## **ENVIRONMENTAL COMMISSION MEETING MINUTES**

### **Wednesday, September 21, 2016**

b. **Name:** Austin Oaks Planned Unit Development, C814-2014-0120

**Request:** Review and consider for recommendation the environmental aspects of the proposed PUD, including code modifications and environmental superiority

# TODAY @ Austin

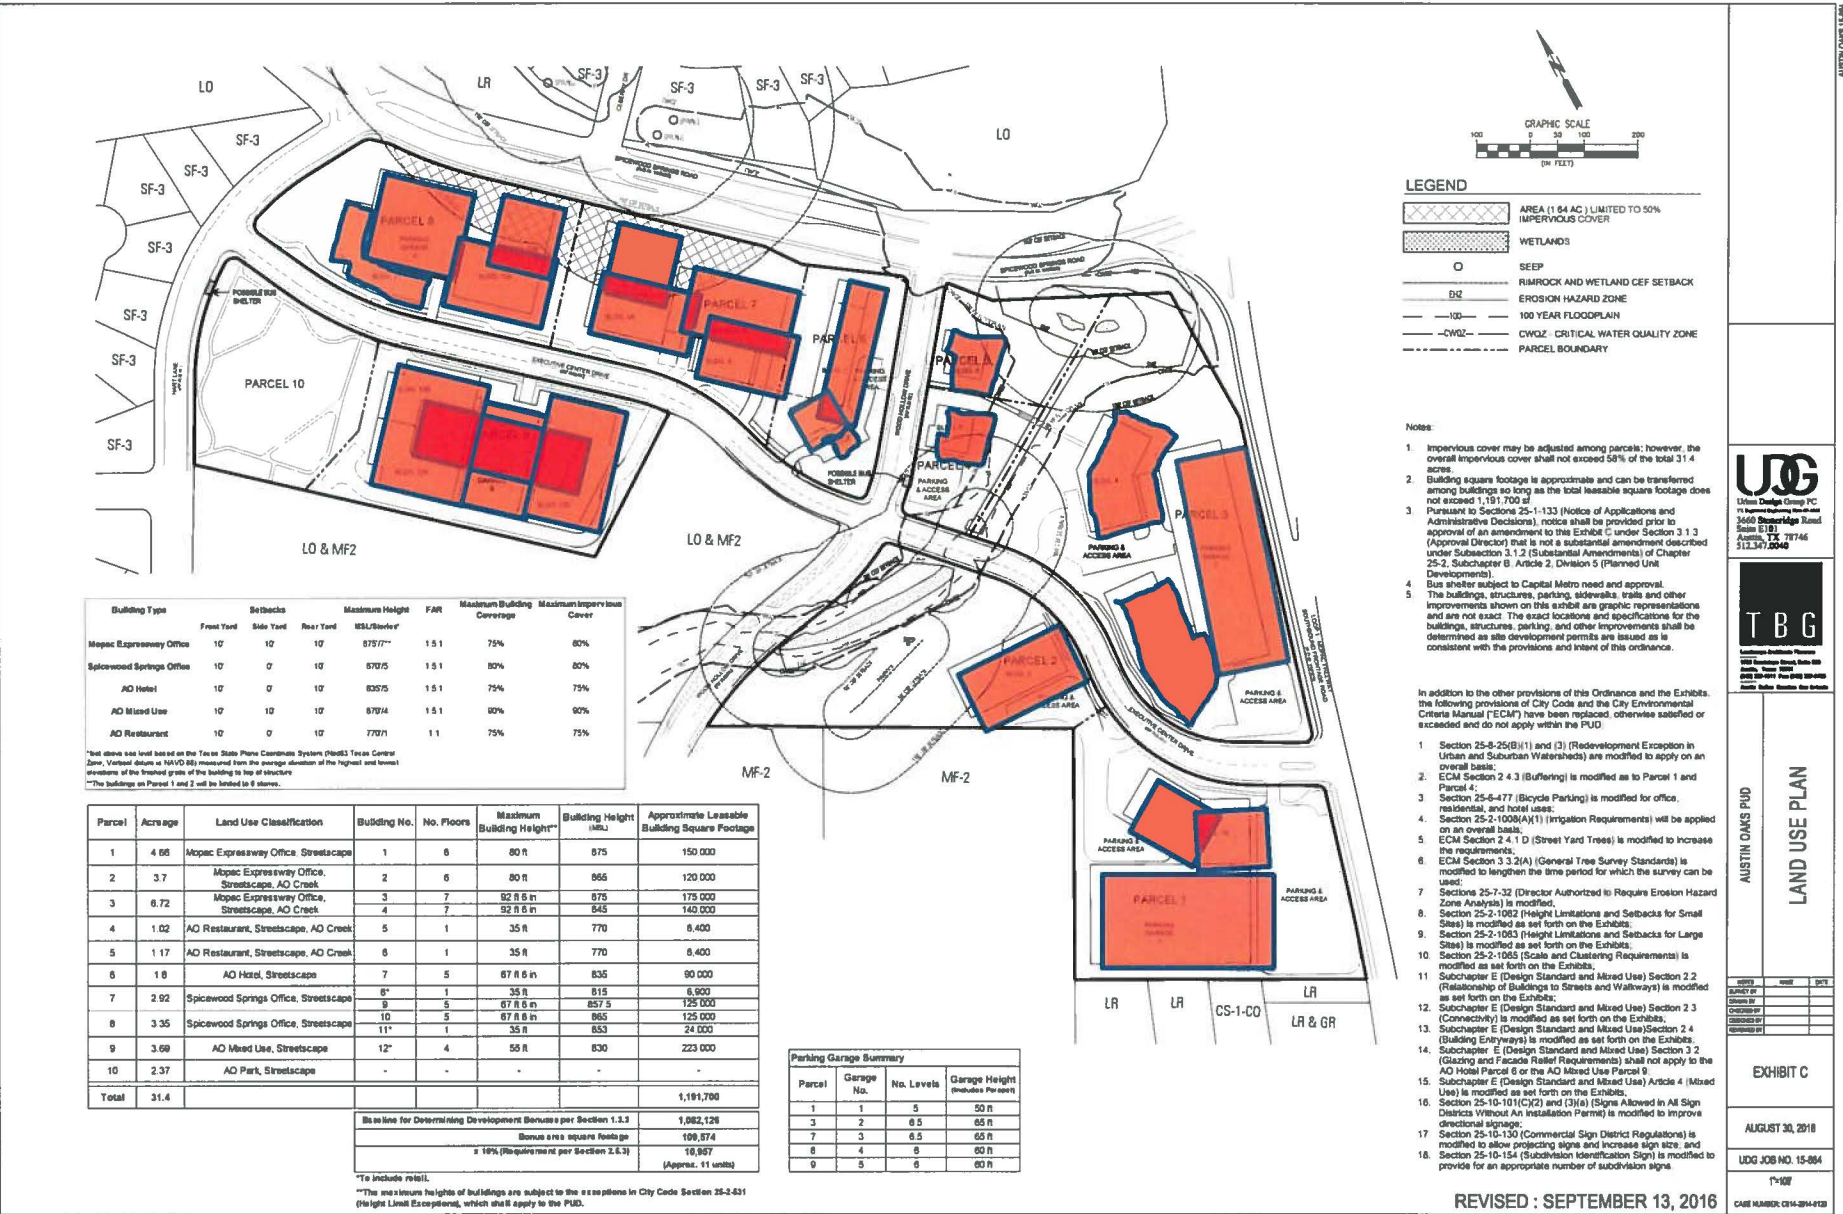
Existing development: 12 low-rise office buildings (8 two-story & 4 three-story W/ zero parking garages) 446,000 square feet office floor area, Mature Wooded Tree Canopy over ALL Surface Parking and individually zoned parcels

23 buildings (5 are car park garages), Up to 8+ stories tall, Elimination of 50+% of the Tree Canopy, and Significant changes to the topography and grade changing the watershed in the negative for neighboring property owners.

# Use FEET (FT) to Measure Height not Mean Sea Level (MSL)

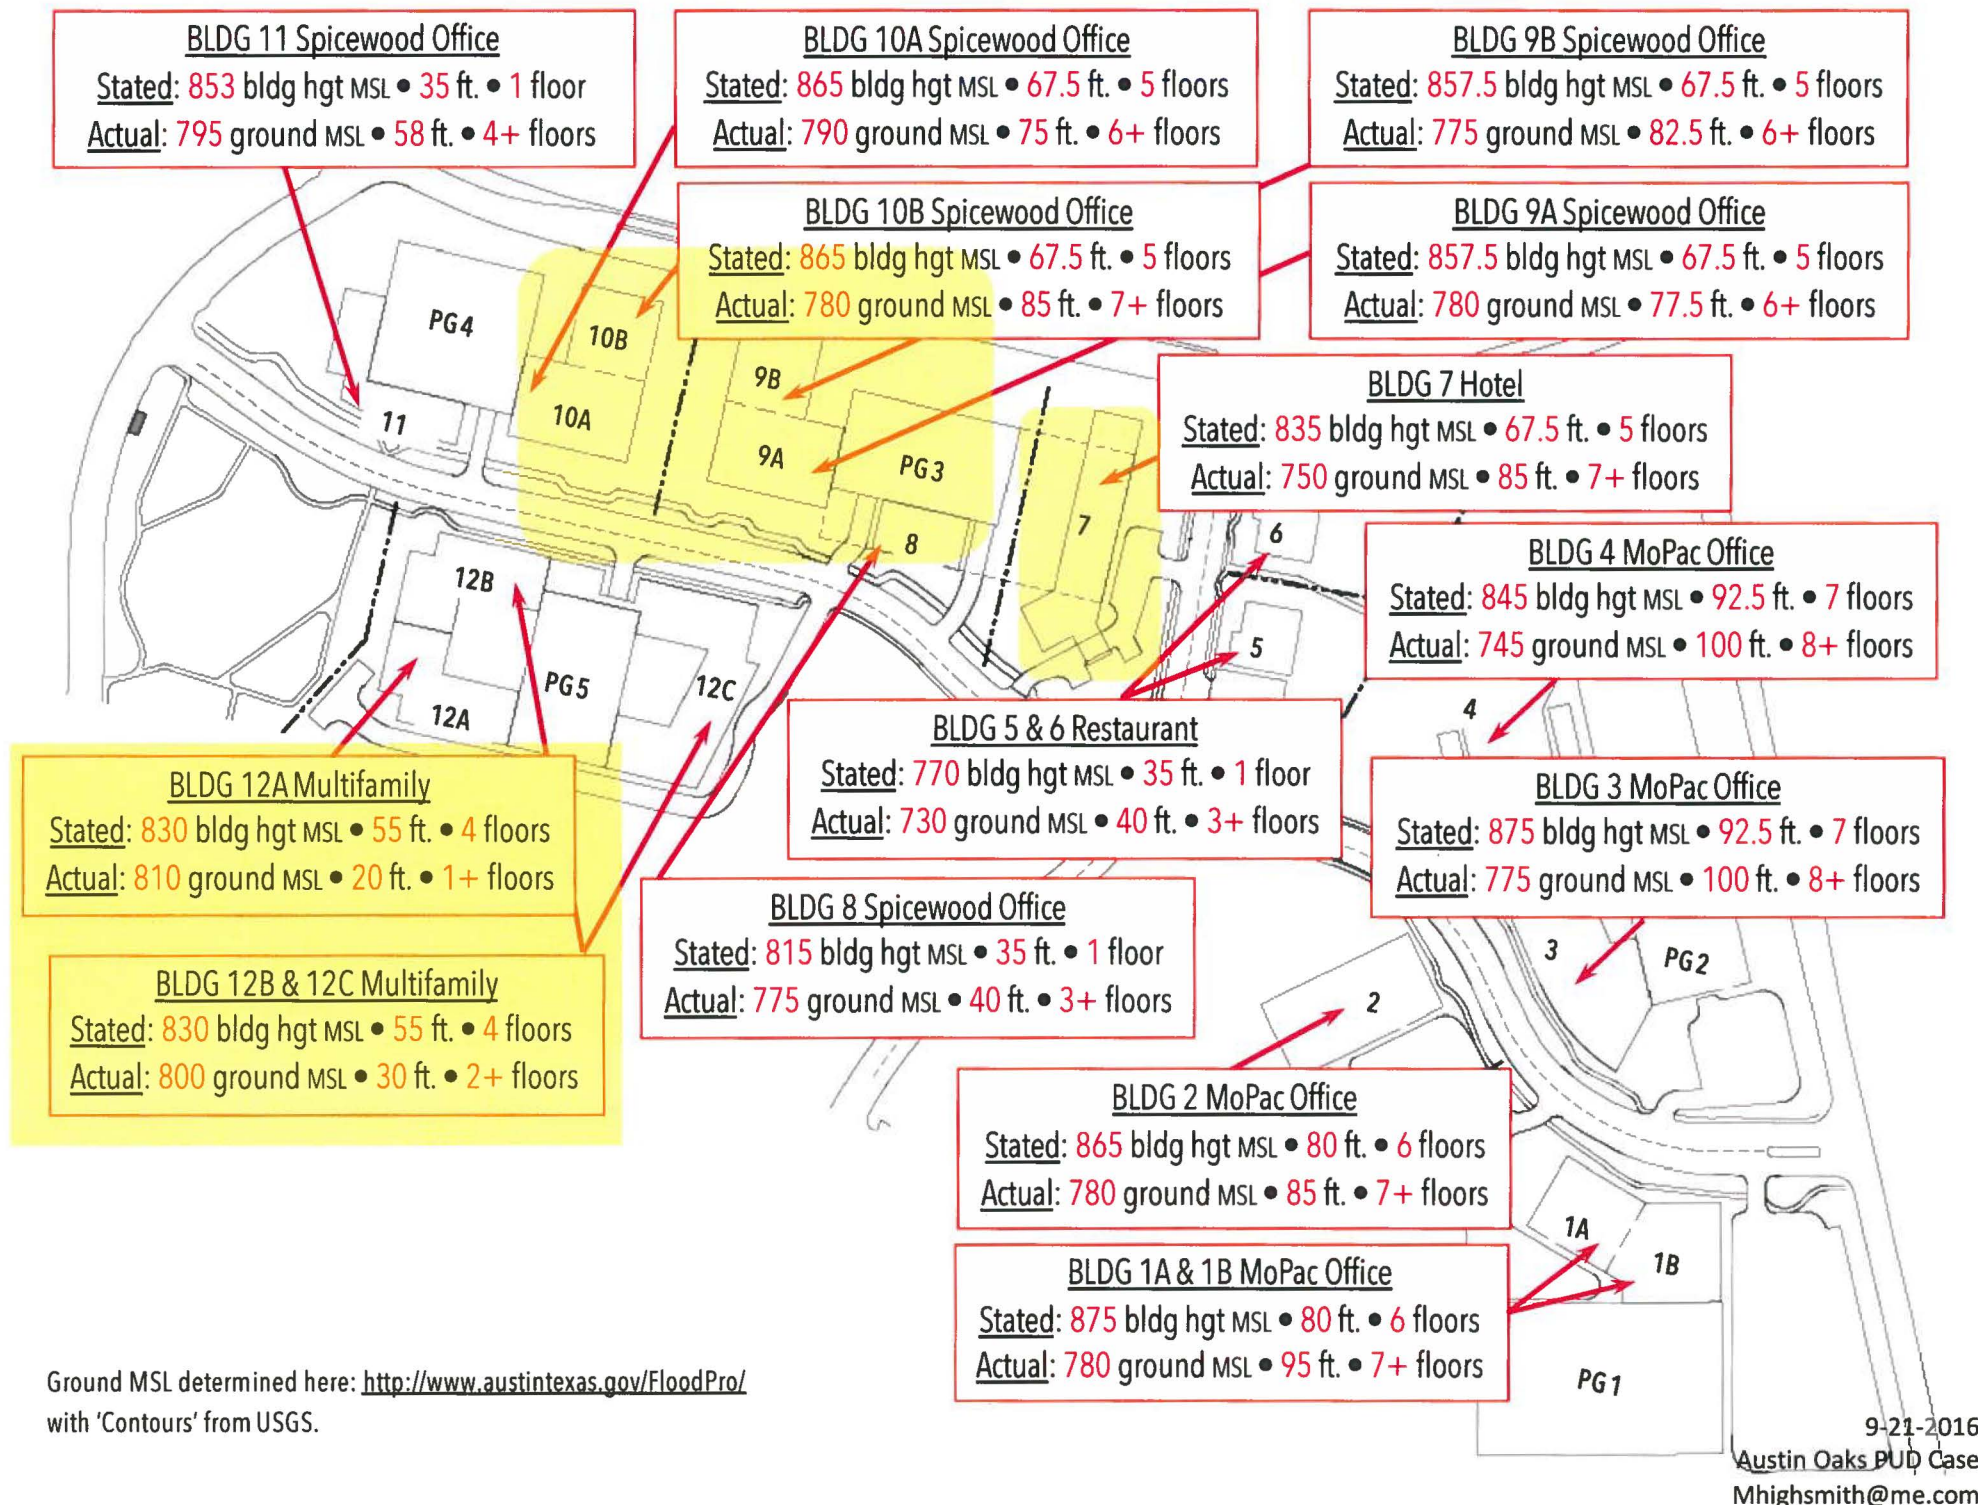
Using Mean Sea Level (MSL) is an OPAQUE and MISLEADING MEASURE.

Let's STICK to BUILDING HEIGHT STANDARDS to be MEASURED in FEET ONLY.

**\*BACKGROUND:** MSL was used for illustrative purposes during the Charrette process to provide Stakeholder Residents of various *Elevations* surrounding the property with a means to consider their own *Elevation* and flood run off (drainage) as well as HEIGHT impact respective to their location.

1. Please do not allow Mean Sea Level measures of this application,
2. Please stick to Building Heights Measured in FEET.
3. MEAN SEA LEVEL –Varies by as much as **40 FT in one parcel** on this property.
4. We need to remove Mean Sea Level from the Land Use Plan entirely and rely on measurable building height in FEET from the ground level.
5. During the Charrette the MSL was asked for to illustrate to neighbors the height seen from North Shoal Creek, Balcones North, Allandale and North West Hills varying elevations.
6. WE NEED TO NOT USE MEAN SEA LEVEL IN THIS LAND USE PLAN AT ALL.
7. IT IMPLIES a SPECIFICITY of a SITE PLAN but it is not the Owner/Developer's SITE PLAN and is therefore MISLEADING, intentionally or otherwise.
8. **WE ASK YOU to TAKE THE MEAN SEA LEVEL HEIGHT OUT OF THIS PLAN ENTIRELY.**
9. IT IS AN OPAQUE and MISLEADING MEASURE.

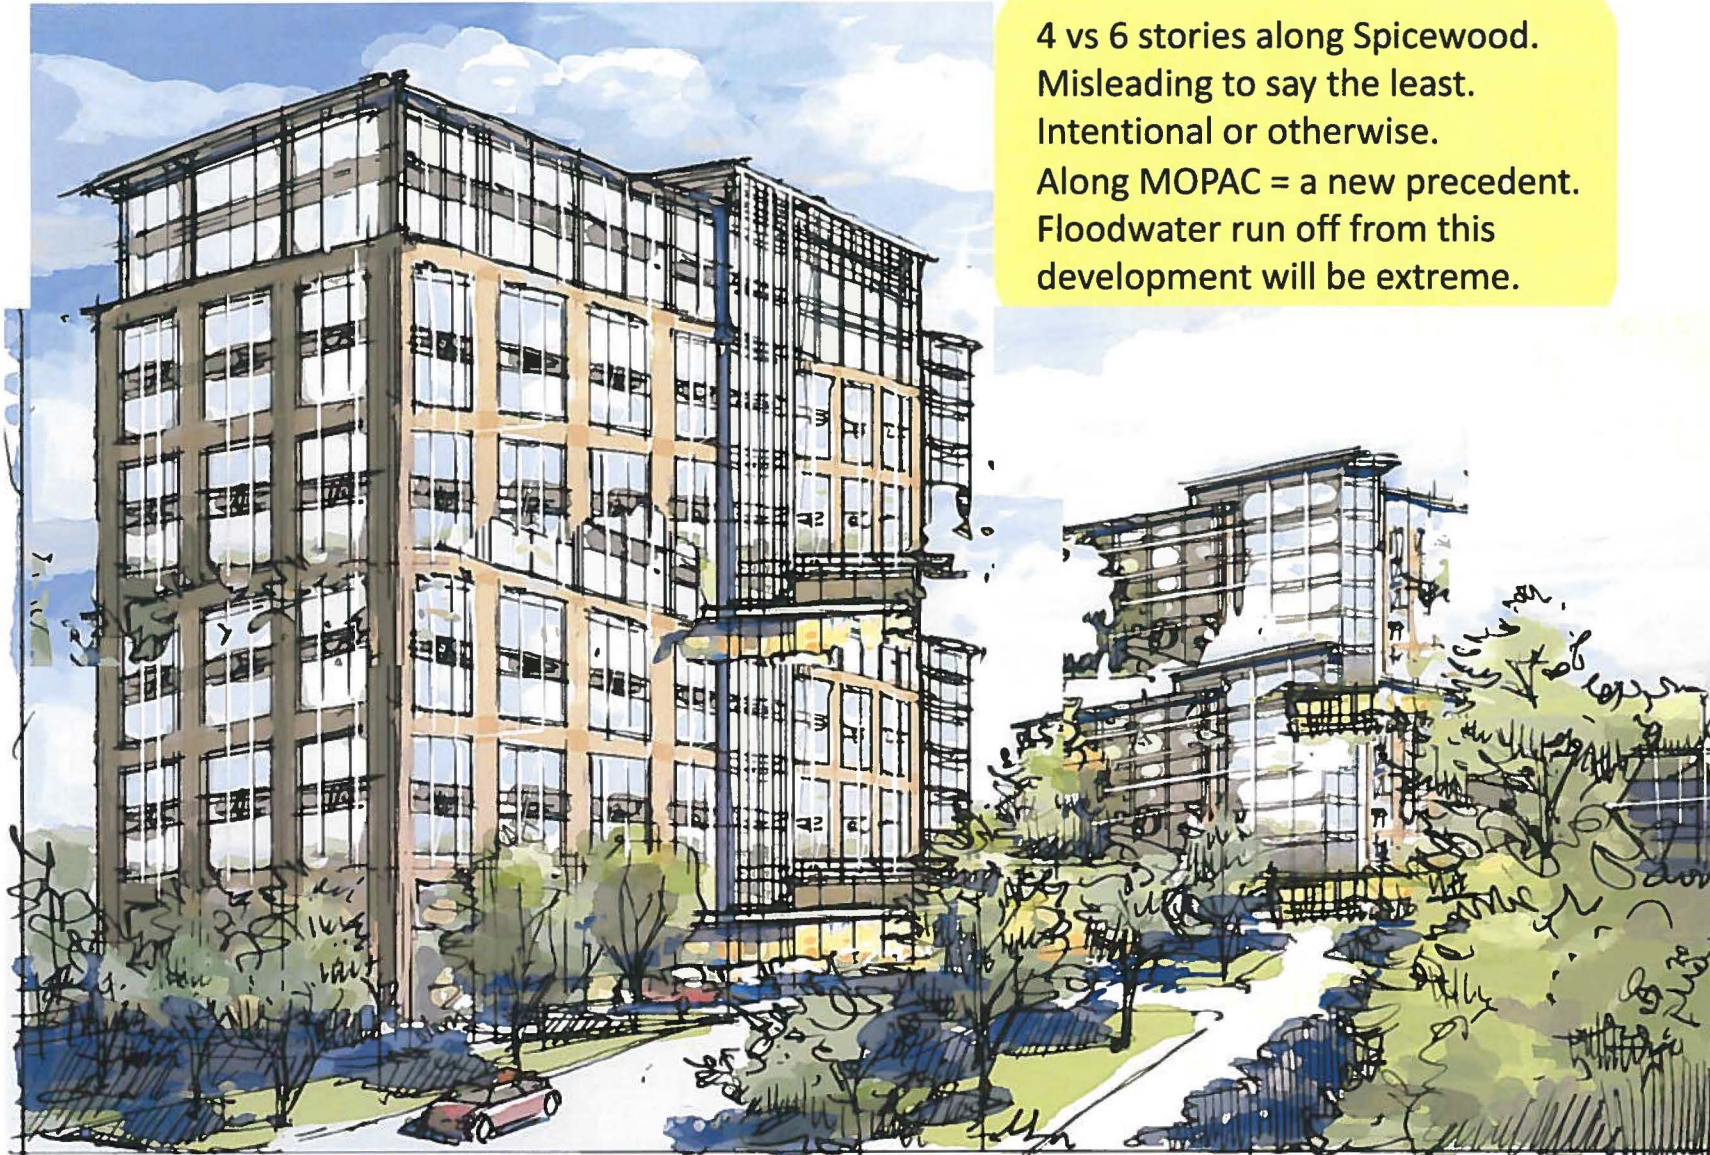
**We were shown these 4 Story Building Rendering from this  
PUD Process since its inception...**  
Actual images prepared by the Owner & Their Agent and Design Agencies

**WHAT it will ACTUALLY be LIKE based on the HEIGHT shown per MSL  
and Building Height FT per the TABLES by Developer.**

4 vs 6 stories along Spicewood.  
Misleading to say the least.  
Intentional or otherwise.  
Along MOPAC = a new precedent.  
Floodwater run off from this  
development will be extreme.

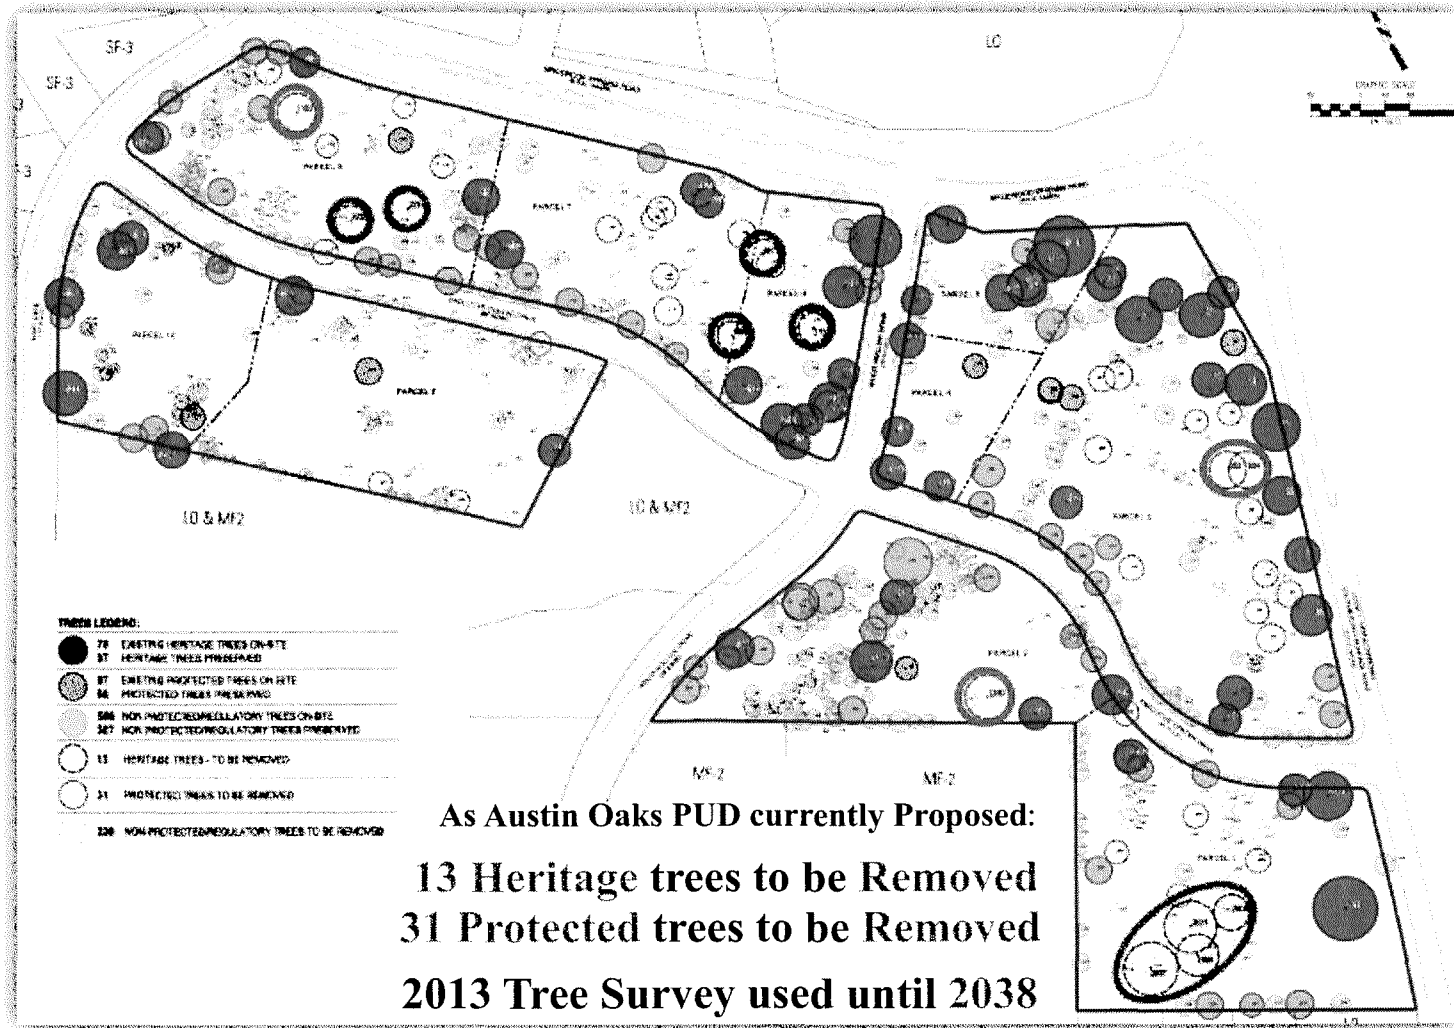
Measure Flood water run off *parcel by parcel* due to EXTREME *Elevation* VARIANCES. Don't measure flood water run off in the AGGREGATE across all parcels. See building plan slide #4 for evidence.

1. We ask you not to allow for the measure of drainage and watershed "run-off" to be calculated in the AGGREGATE across of all the parcels, but rather parcel by parcel because of the extreme elevation differences.

2. Staff has not agreed to allow this AGGREGATE run-off calculation, but the Owner/Developer and their Agent continue to leave this language in the Application.

3. (\*Note: Recall in the previous version the "retention pond" at the TOP of the HILL on HART & EXECUTIVE CENTER DR.? In this current version the drainage is limited to the creek area.)

4. Fewer Trees to capture water and drink it will contribute to the flood run off on this property.
5. Mean Sea Level notations and Building Height notations in the current version indicate extreme SCRAPING of the topography which will CHANGE the RUN OFF to the neighboring properties and the natural WATERSHED.

6. Because the developer is planning the development using *the assumption of AGGREGATE drainage across all parcels*, flood run off will be greater. **(Versus IF development is planned in consideration of flood run off parcel by parcel given the EXTREMEM height variances across all parcels. ← Preferred by the Community.)**

8. *Again, Environmental Commissioners, please do NOT allow AGGREGATE DRAINAGE Calculations. Its bad for the downstream watershed and flooding of neighboring property owners.*
